# CD-CPC-2025-00042

The applicant is seeking approval of a major amendment to a previously approved development plan to construct a mixed-use apartment complex on each site.

Neighborhood Planning and Development Committee

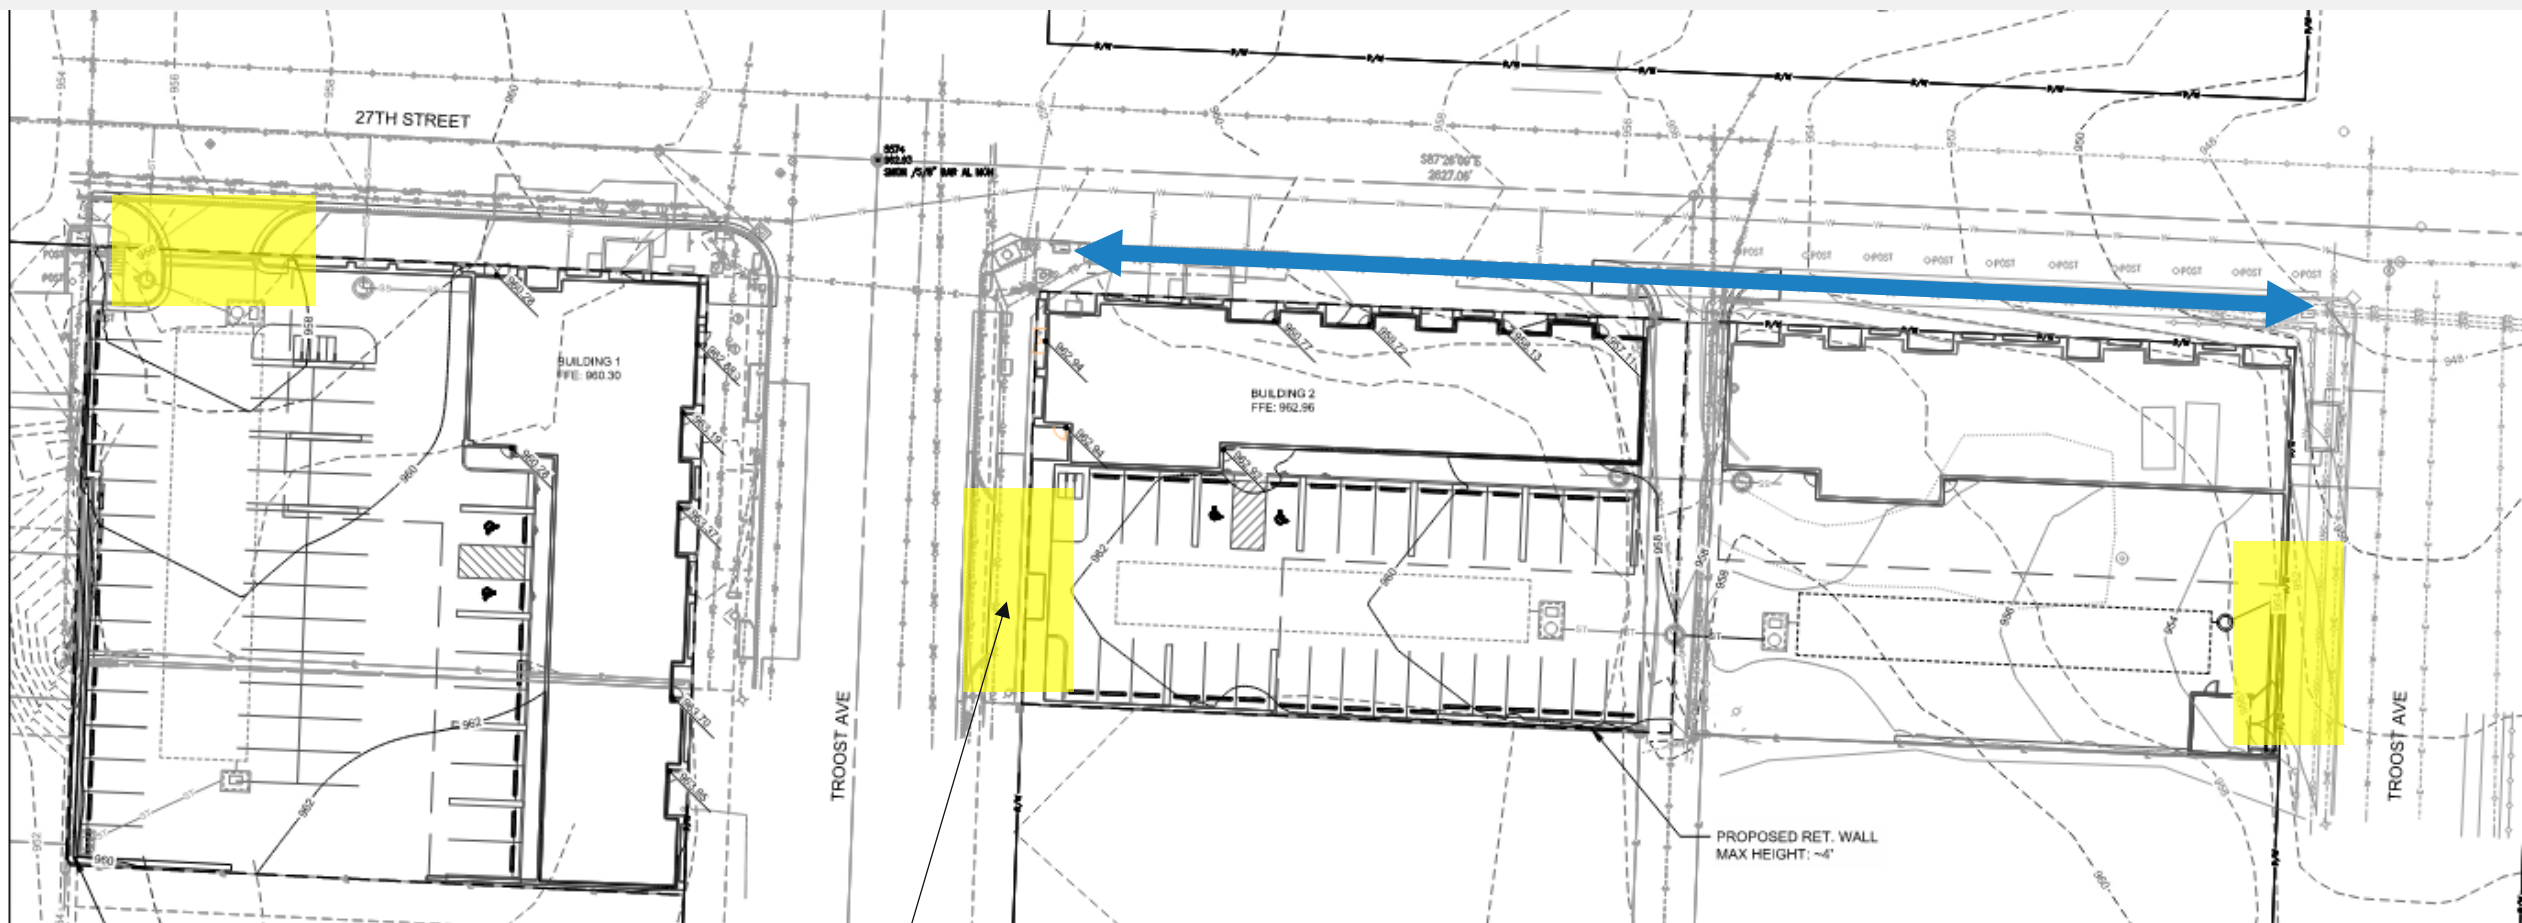
- Site 1 has an ingress/egress point off of 27th St. The vehicular circulation is appropriate for the proposed use.
- Site 2 has an ingress/egress point off of Troost Ave. Due to the pedestrian and transportation-oriented development goals for Troost Ave, adding/maintaining a vehicular ingress/egress point is not ideal. However, the Troost Ave access point provides building orientation continuity with Site 3 (CD-CPC-2025-00043).

Existing curb cut.
